ADA Curb Ramp New Construction Inspection Form (Perpendicular)

311th

24952.54

Kaybern

PERPENDICULAR RAMP (PR)

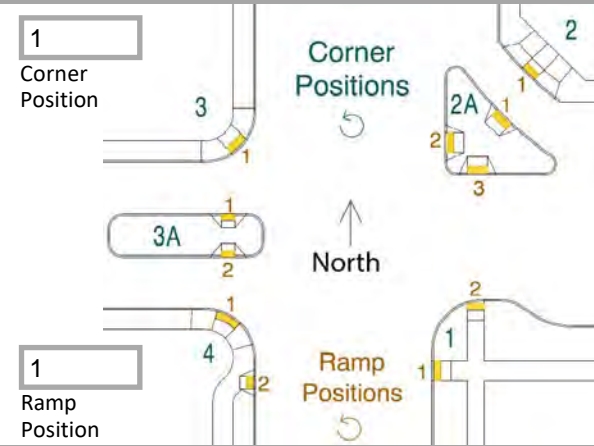
IITD, gt2. Lip at front of TD
